**RFP 2025-02  
REQUEST FOR PROPOSALS  
FOR THE  
RENOVATION OF ROCKLAND GREEN ADMINISTRATIVE HEADQUARTERS  
AND  
CONSTRUCTION OF AN IMMERSIVE THEATRE EXPERIENCE  
AT  
172 MAIN STREET IN NANUET, NY 10954**

**To:** All Potential Proposers  
**From:** Rockland Green  
**Subject:** Addendum Number 3  
**Project:** Rockland Green Renovation & New Immersive Theatre Experience at 172 Main Street, Nanuet, NY 10954  
**RFP No.:** RFP 2025-02  
**Date:** April 10, 2025

This Addendum Number 3 is issued to modify the Request for Proposals No. 2025-02 (the “RFP”) for the above referenced project. All potential Proposers are hereby notified of the following change:

**M201**

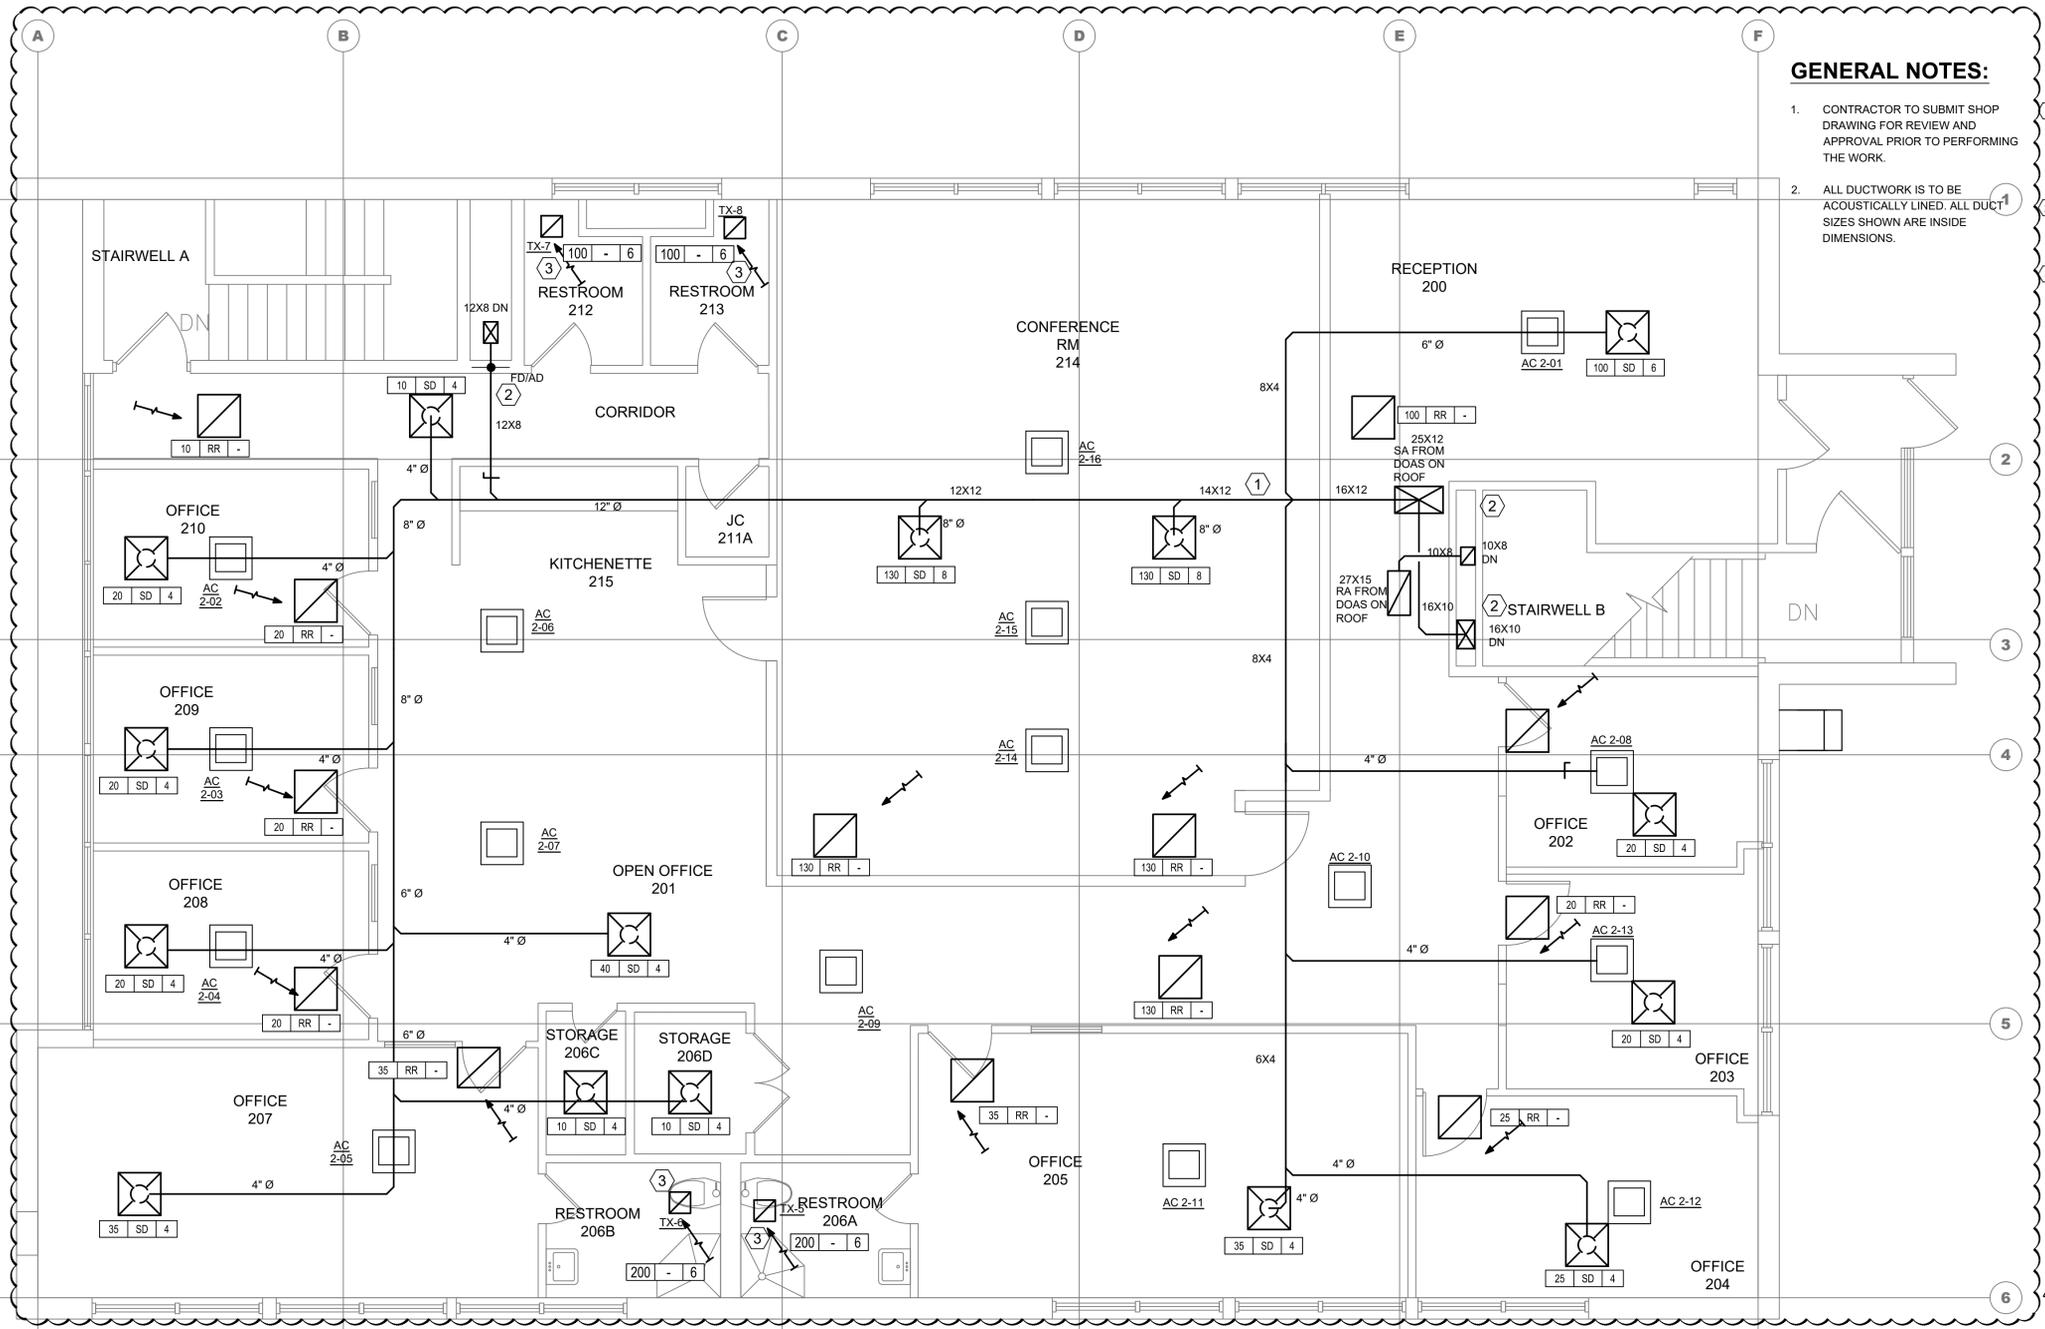
- M102 Revised Second Floor Plan Piping Layout to ensure adequate cooling is provided for the Conference Room.
- M201 Revised duct layout on First Floor, added return registers in various locations, added fire dampers at fire rated partitions and added General Notes to clarify the work.

© COPYRIGHT, MICHAEL SHILALE ARCHITECTS. ALL RIGHTS RESERVED.  
Drawing Title  
**MECHANICAL SECOND FLOOR DUCTWORK INSTALLATION**  
Drawing No.  
**M202**

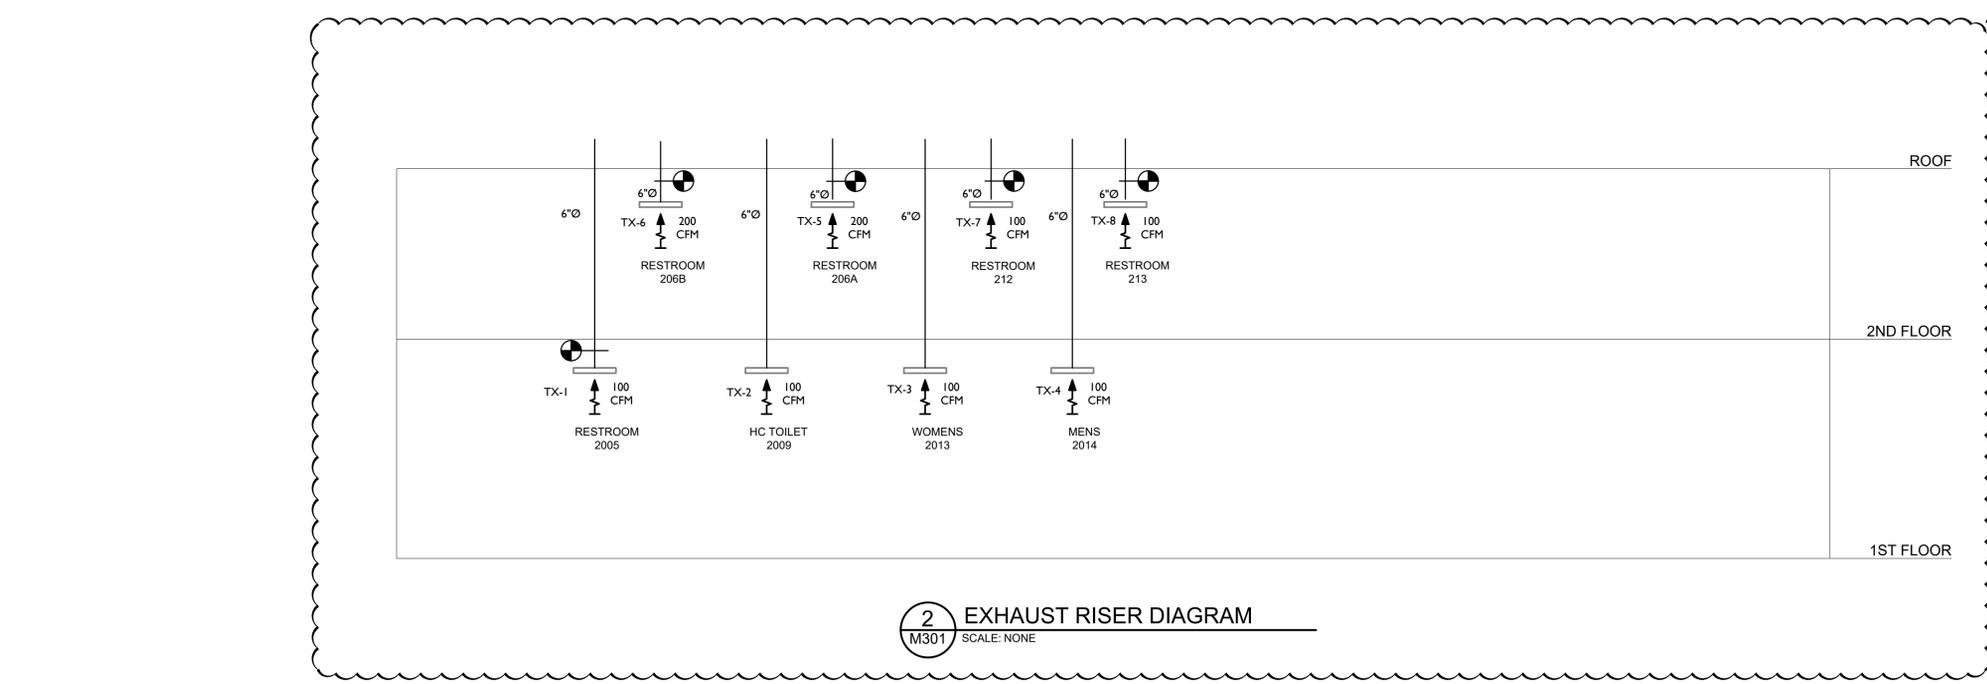
- M202 Revised duct layout on Floor to ensure adequate ventilation is provided throughout. Separated duct connections at indoor cassette and added supply diffusers and return registers throughout. Duct sizes are corrected and added General Notes to clarify the work.

© COPYRIGHT, MICHAEL SHILALE ARCHITECTS, ALL RIGHTS RESERVED. Drawing Title <b>AIR RISER DIAGRAM</b>	Drawing No. <b>M301</b>
--	----------------------------

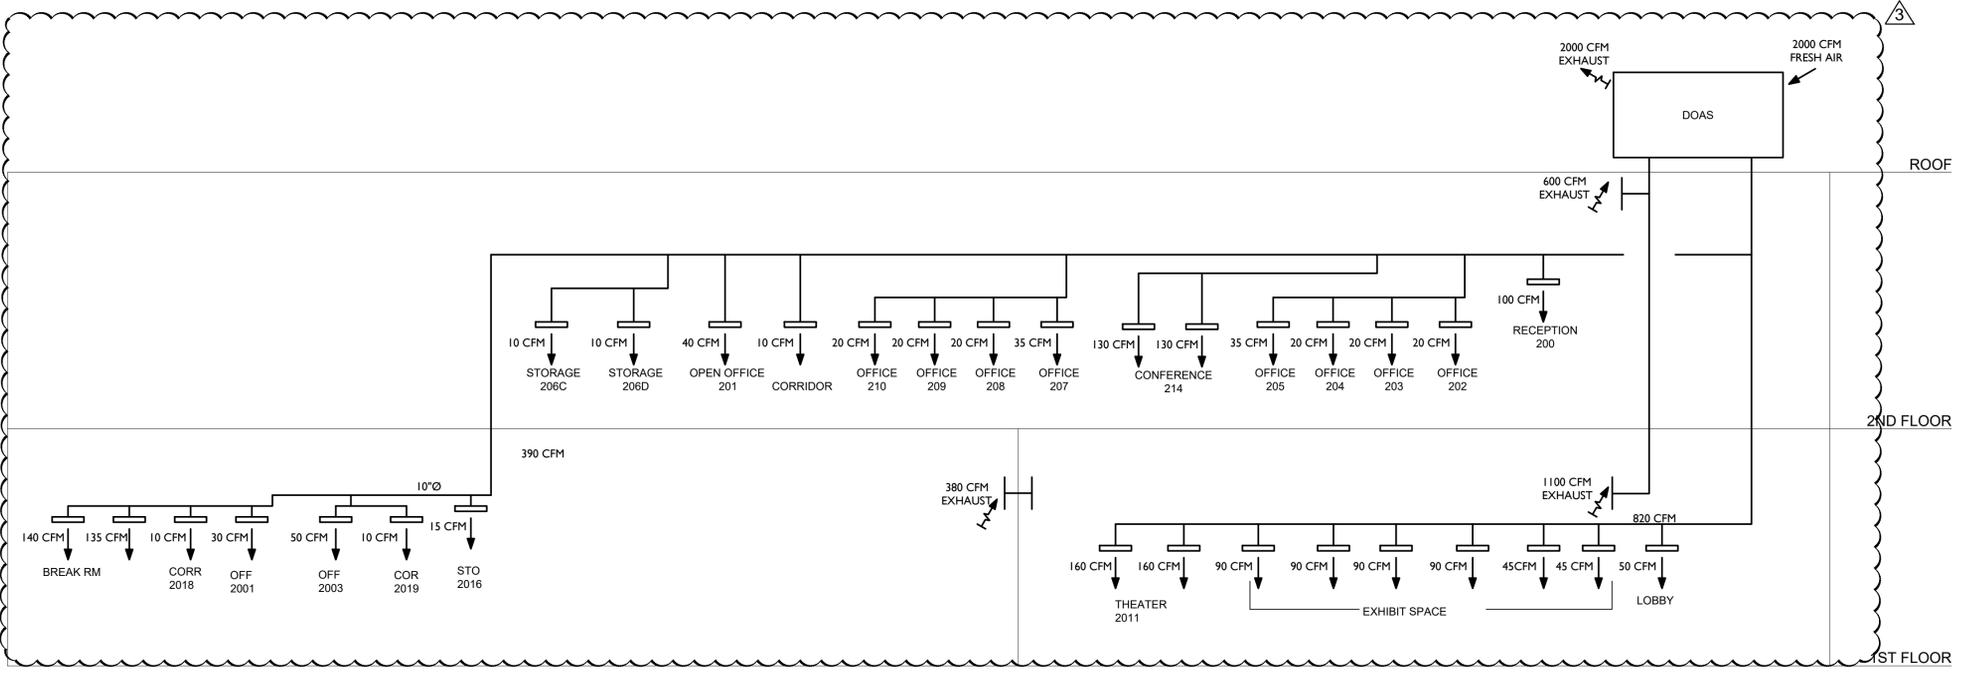
- M301 Added Exhaust Air Riser Diagram for all Toilet Exhausts. Revised Ventilation Air Riser Diagram to include all room names and airflow rates.
- M302 Revised VRF Piping Riser Diagram to match floor plans and schedules.

Drawing No.  
**E001**

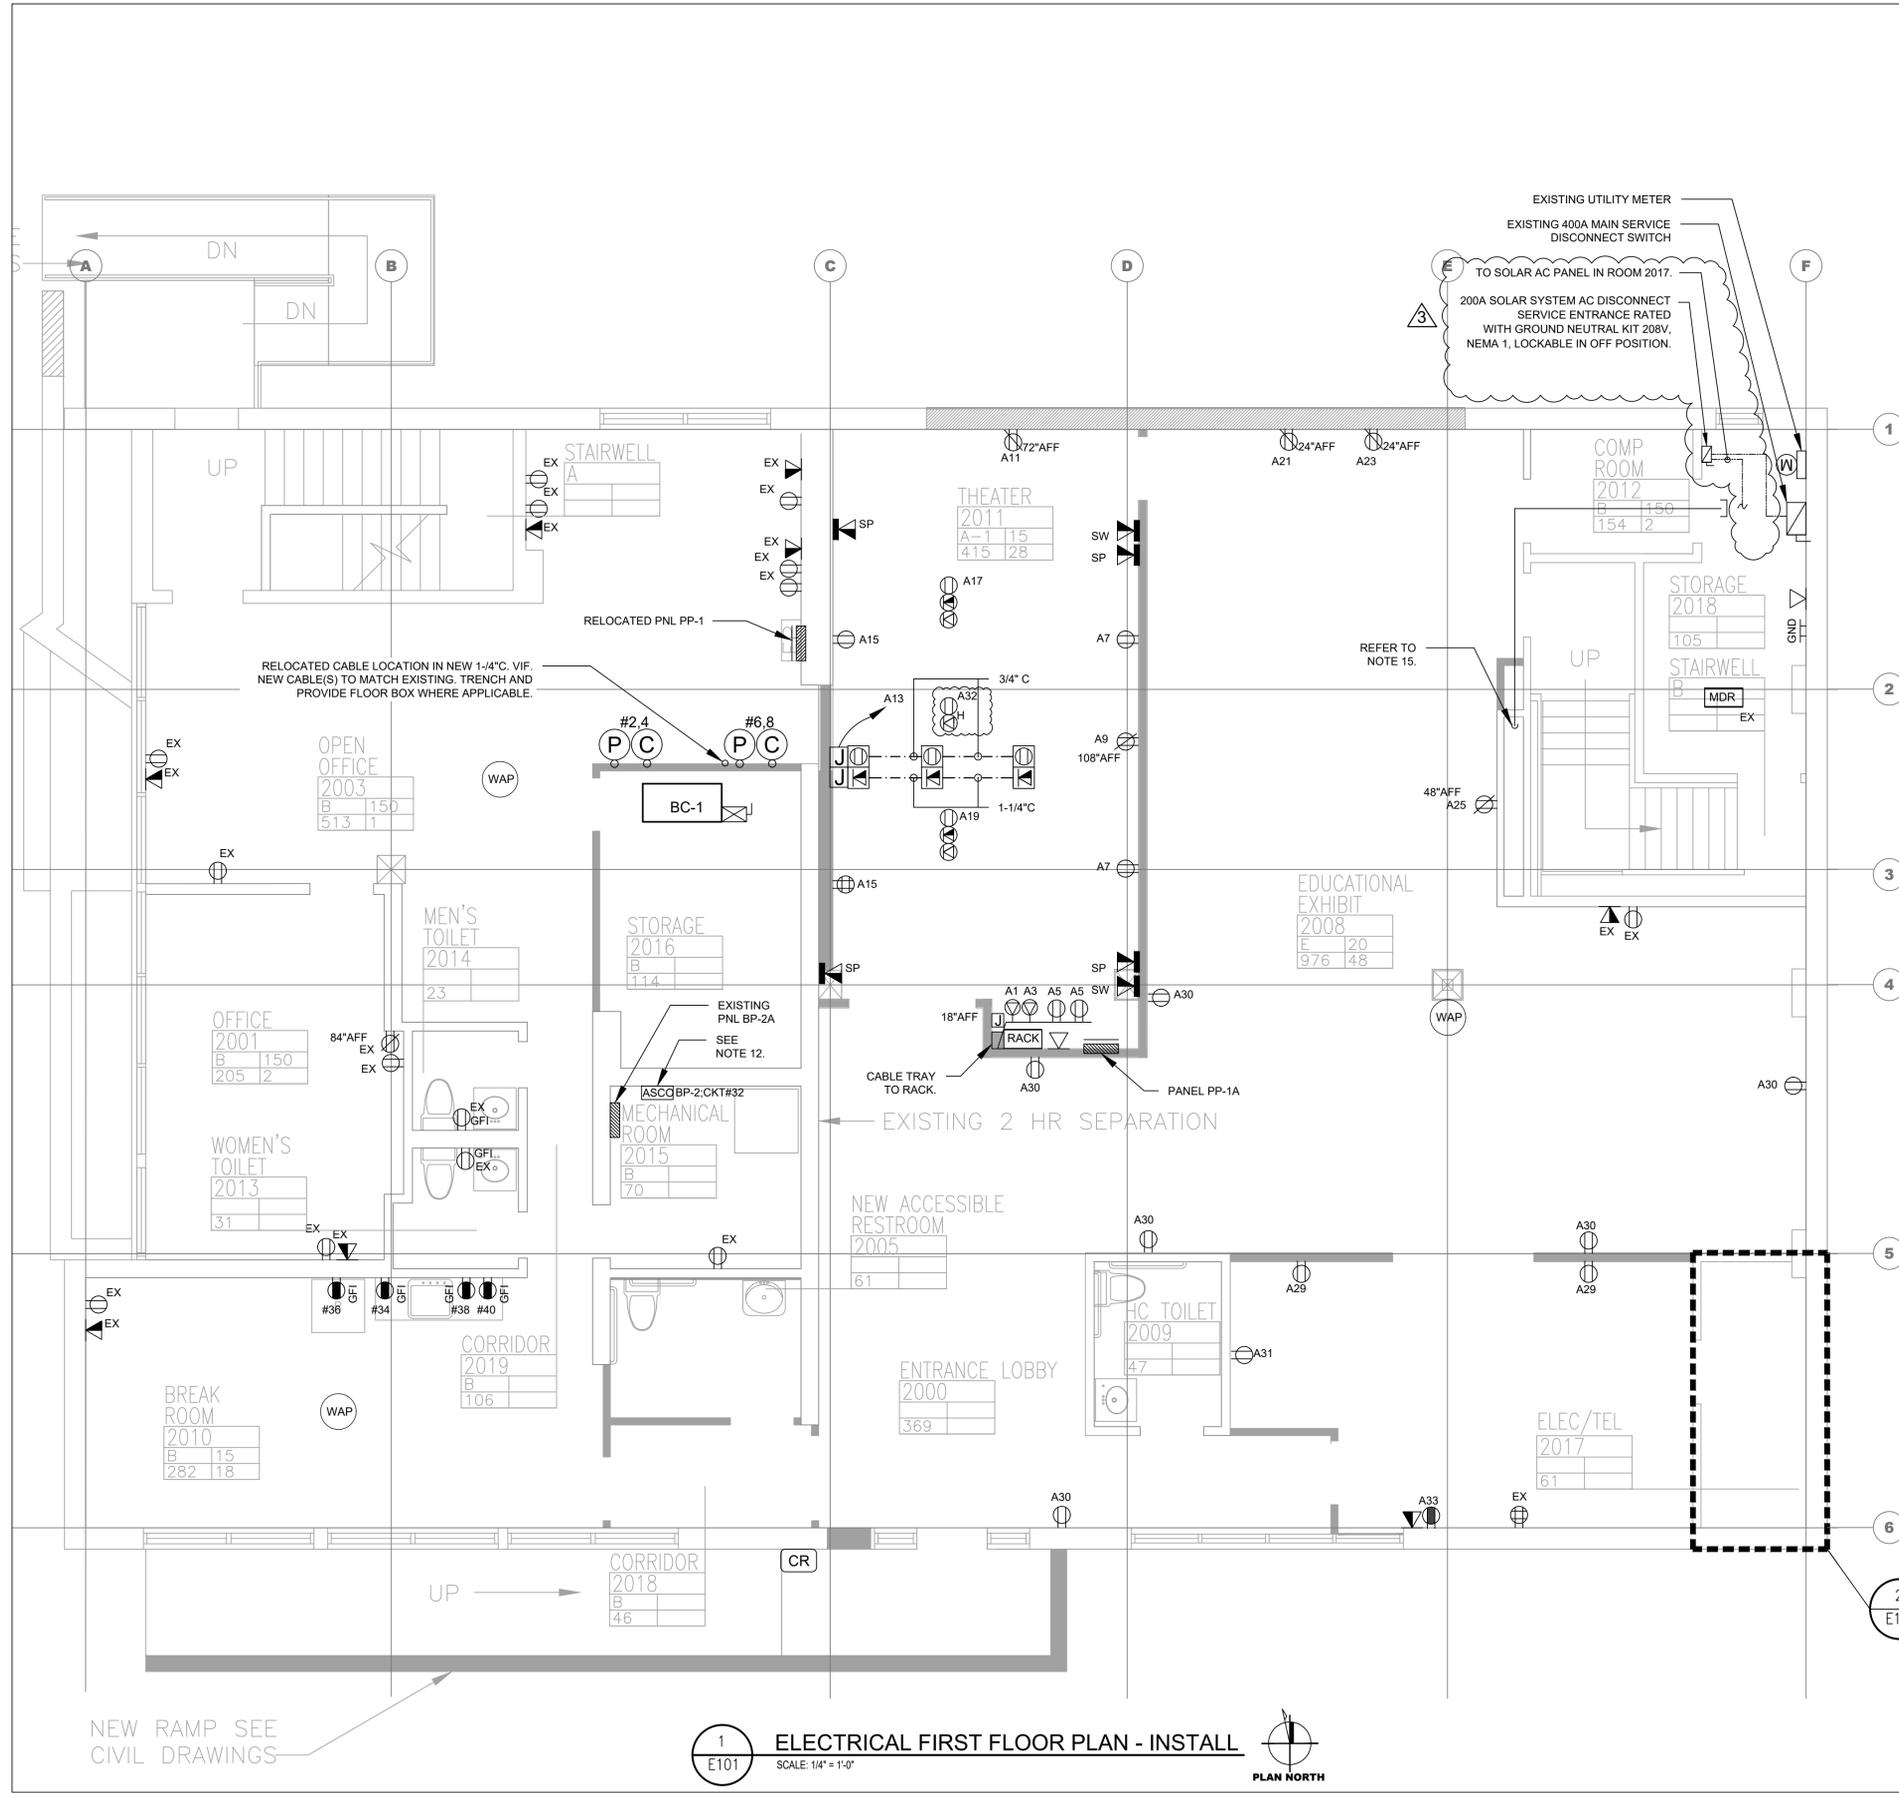
- E001 Revised Communication Symbol list.
- E101 Revised floor plan to include revisions coordinated with Theater, Solar, and Mechanical changes.
- E111 Revised floor plan to include revisions coordinated with mechanical changes.
